ATTACHMENT 1

Proposed Change to DPR-30

Quad Cities  
DPR-30

### Discussion of Quad Cities Unit 2 Reload 6, Cycle 7 (Q2R6C7) Proposed Technical Specifications Changes

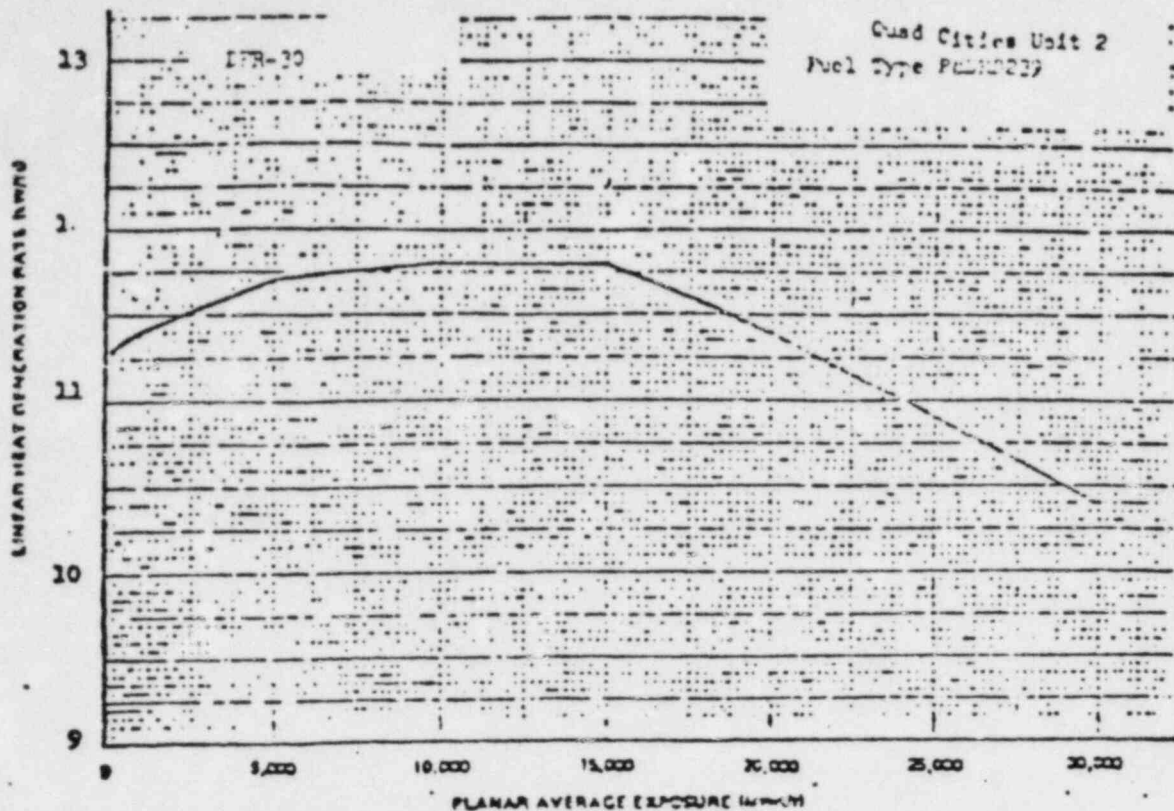
The current Quad Cities Unit 2 Technical Specifications establish an ODYN "option B" MCPR operating limit of 1.37. The option B approach takes credit for actual scram time performance relative to the Technical Specifications surveillance limits and therefore requires a scram time conformance surveillance. Exceeding the surveillance criterion ( $Z_B$ ) invokes a MCPR penalty in the form of a linearly increasing limit between the option B value (currently 1.37) and the option A value (1.42). The Q2R6C7 reload analysis (see Attachment 4 section 12) establish a Cycle 7 option B MCPR limit of 1.32 (which bounds the results for all Cycle 7 fuel types) based on the load rejection without bypass event. Full reduction of the Technical Specifications to the allowable 1.32 MCPR value could require future Technical Specification changes if subsequent reload require slightly higher MCPR limits. Therefore, in order to simultaneously preserve the option to review future reloads under 10 CFR 50.59 and improve plant operating margin to MCPR, a value of 1.34 is proposed for the Technical Specifications option B MCPR limit. Based on the option A value provided in Attachment 4 (increased by 0.02 for the above reason), the linearly increasing MCPR penalty was determined and included in the proposed specification change.

The reduction in the operating MCPR limit calculated by GE (from 1.37 to 1.32 for ODYN option B) is largely a result of improved assumptions in analyses assumed that the recirculation pump M/G set which is driven from the generator would transfer to off-site power in 0.42 seconds. This transfer actually occurs in less than 0.1 seconds which precludes recirculation pump run-up during the postulated load reject without bypass event.

1.34 for  $T_{ave} \leq 0.73$  secs

1.39 for  $T_{ave} \geq 0.86$  secs

$0.385 T_{ave} + 1.059$   
for  $0.73 < T_{ave} < 0.86$  secs

Figure 3.5-1 Maximum Average Planar Linear Heat Generation  
Rate (MAPLHGR) vs. Planar Average Exposure  
(Sheet 3 of 5)

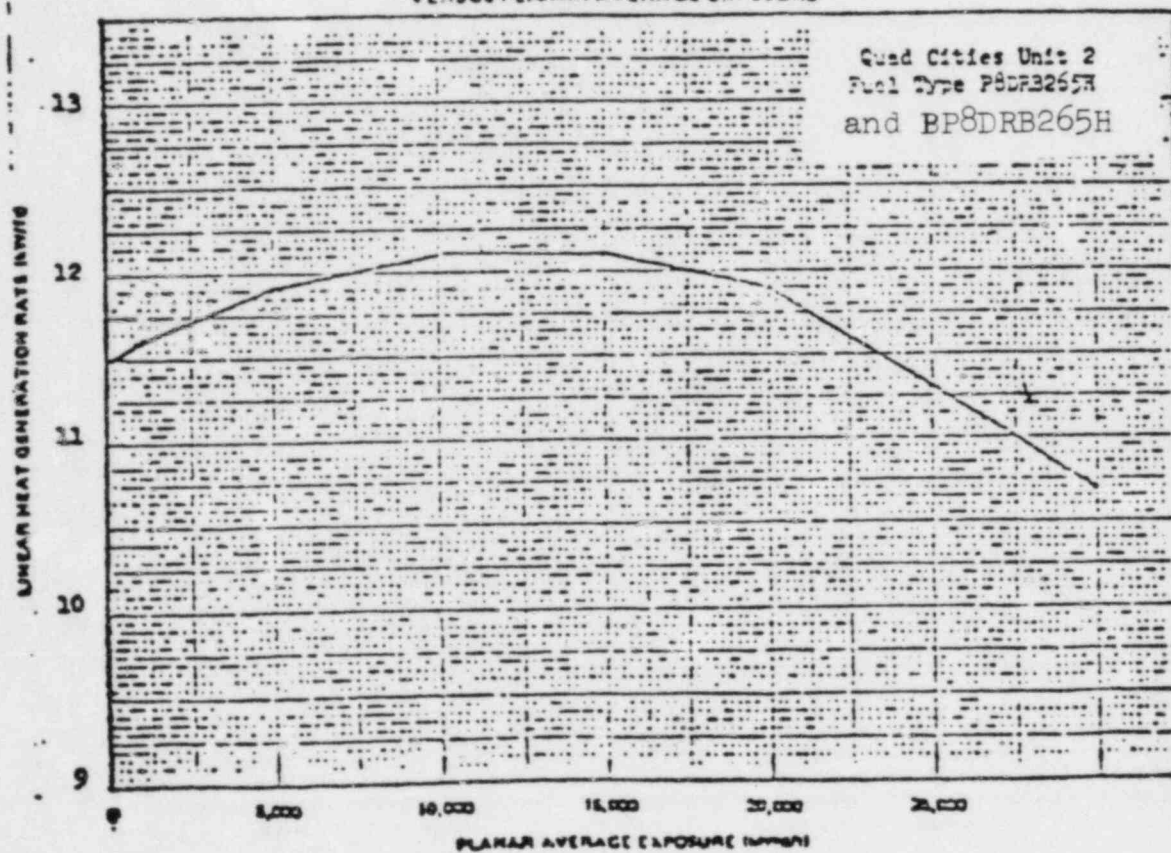
Reference (c) contains the previously approved ECCS analysis for Quad Cities Units 1 and 2 and continues to serve as the basis for the MAPLHGR limits. The proposed Technical Specifications change (Attachment 1) revises the MAPLHGR curve for fuel type P8DRB265H to also apply to the Cycle 7 barrier reload fuel (fuel type BP8DRB265H) which exhibits the same MAPLHGR limit behavior as a function of exposure. The application of non-barrier MAPLHGR limits to barrier fuel of the same nuclear design was confirmed by GE and has been previously approved by the NRC (see Technical Specification 3.5-1 sheet 2). This label change is therefore administrative and in our assessment is not required for Q2C7 operation since there is a precedent from the previous reload that the non-barrier MAPLHGR limits apply to barrier fuel. However, to avoid confusion, the label change is being formally submitted.
